AGENDA

Village of Summit Plan Commission Thursday, July 16, 2026, 5:30 p.m.

VILLAGE OF SUMMIT PLAN COMMISSION ZONING REPORT

RE: **Business Plan of Operation Amendment – Business Name & Operational Changes Signage**
34422 Delafield Road (SUMT0669017)

Figure 8.1 - Lighting family and hierarchy.

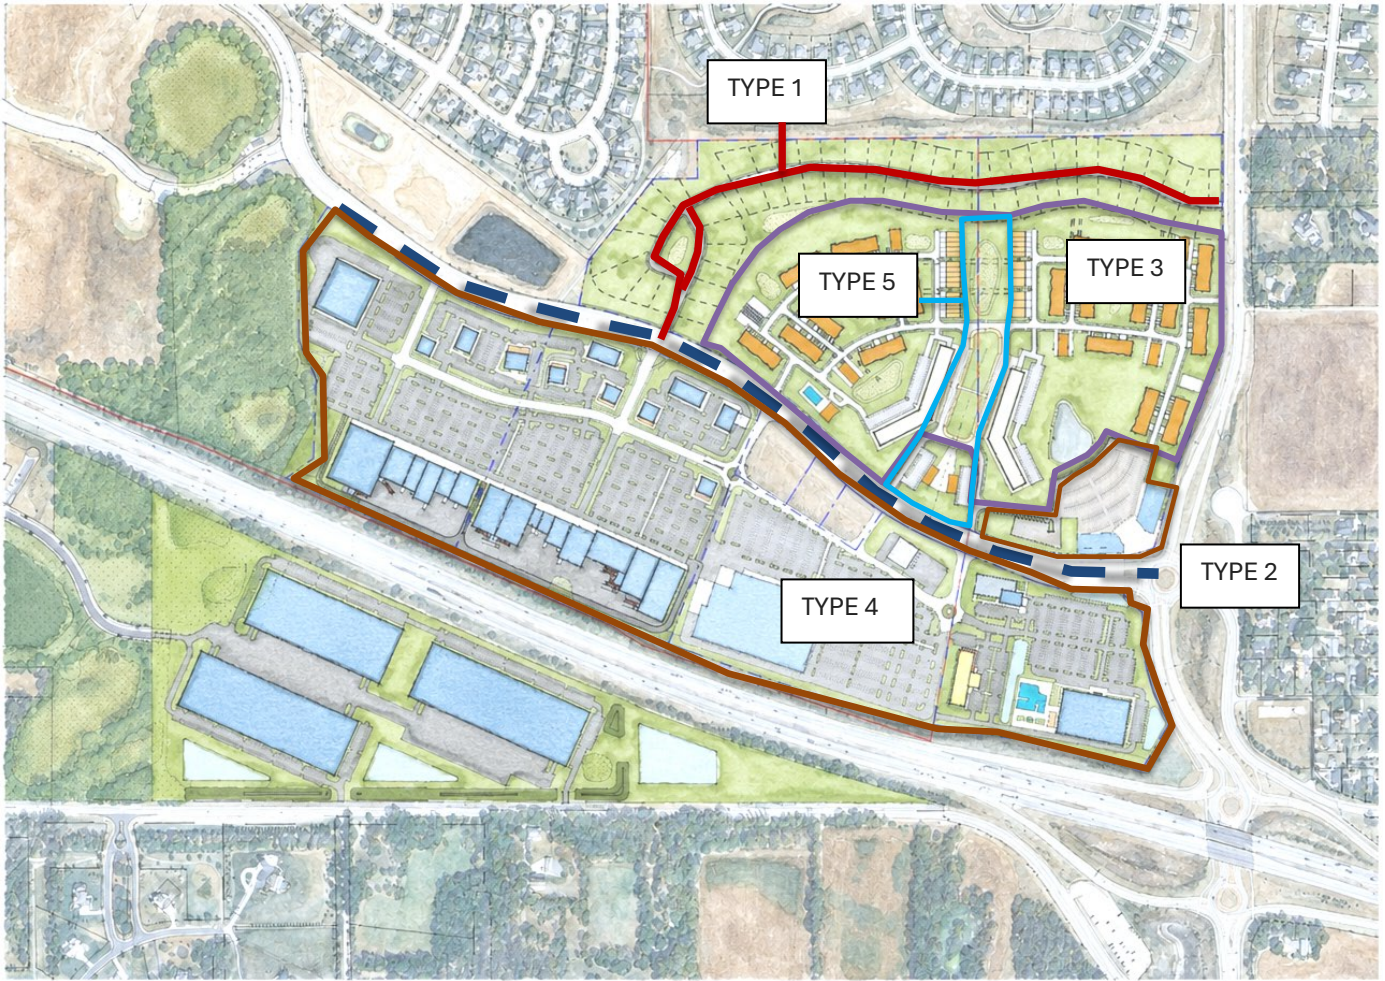
- Plan Commission should provide feedback regarding the types of pole lighting.

- Plan Commission should consider pole height and frequency of lighting. The Village of Summit general design guidelines limit pole lights to 15 feet, not including a 3-foot base. Hope Church has 27.5 ft. tall light poles.
- Plan Commission may also want to consider the timing of lighting and whether certain lights can be dimmed or turned off at night.

Figure 9.1 - Sign family and hierarchy.

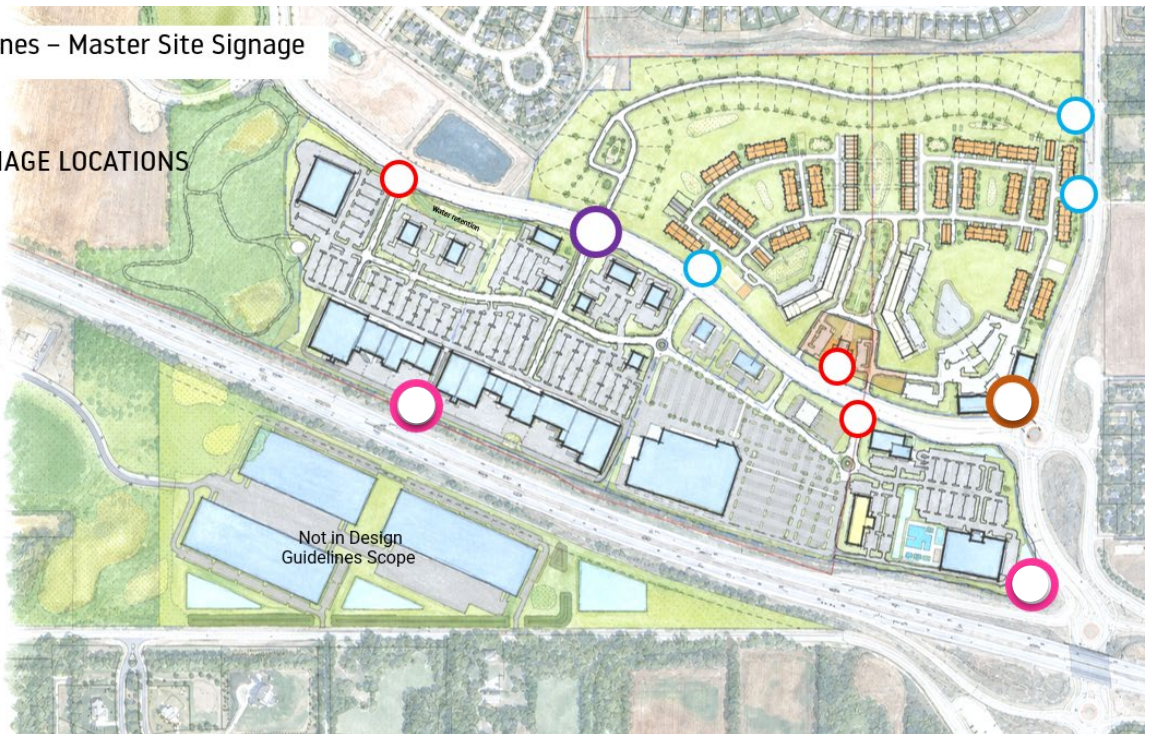
- Plan Commission should review the sign location and standards carefully.
